There are a few things that need mentioning concerning the pc board:

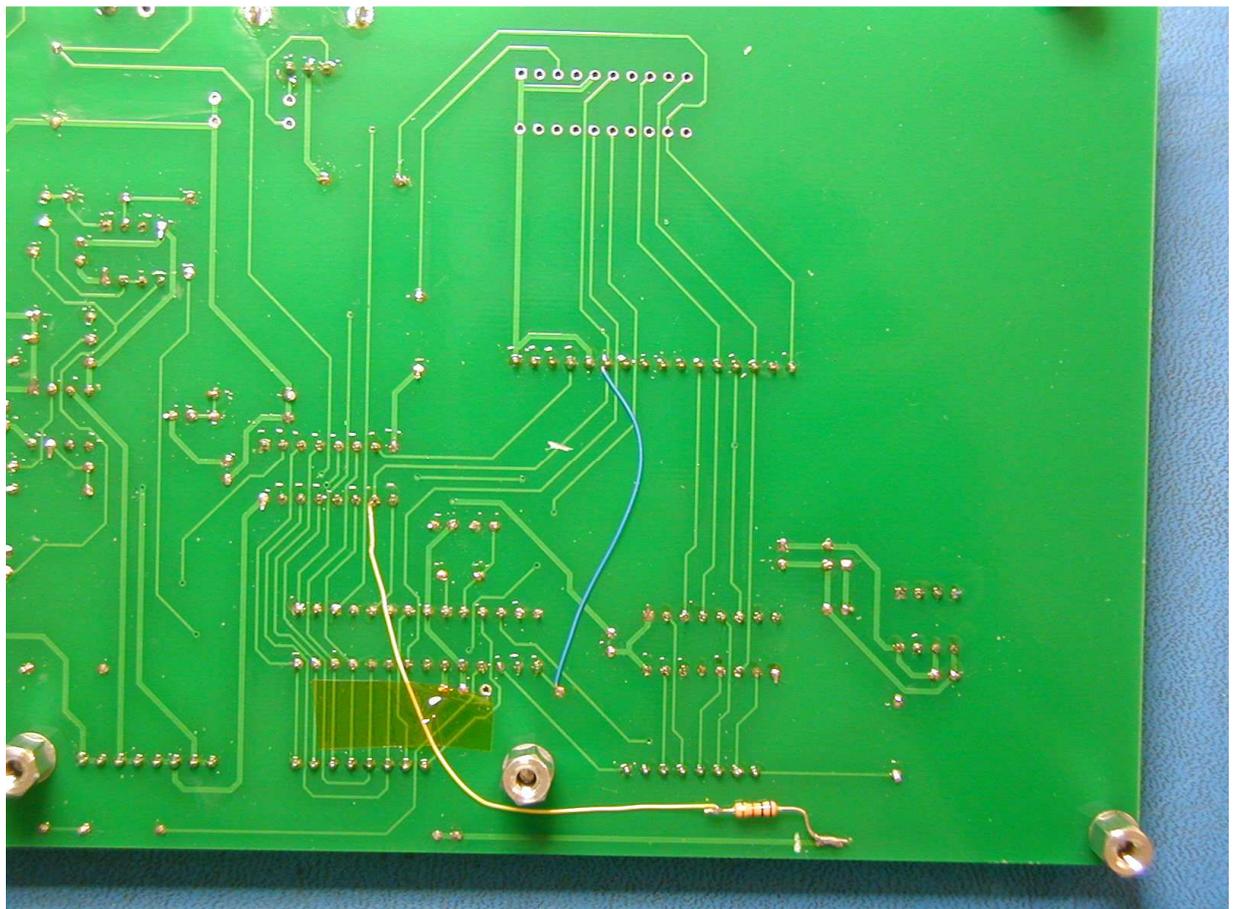
There are two cuts and two jumpers which you will need to add to your board before using it:

- 1) U2 pin 10 is no longer used for the LCDE signal. Instead, LCDE is driven by U1 pin 15.
- 2) The TP3 test point, which was connected to ground, needs to be isolated from ground, so that it can be used as an oscilloscope trigger output. Cut the trace leading to it, and connect it with a 1K resistor in series to U2 pin 10. Add a label on the board to indicate that this is the trigger output and not ground. Here is a photo showing the cuts and jumpers on the bottom of the board:
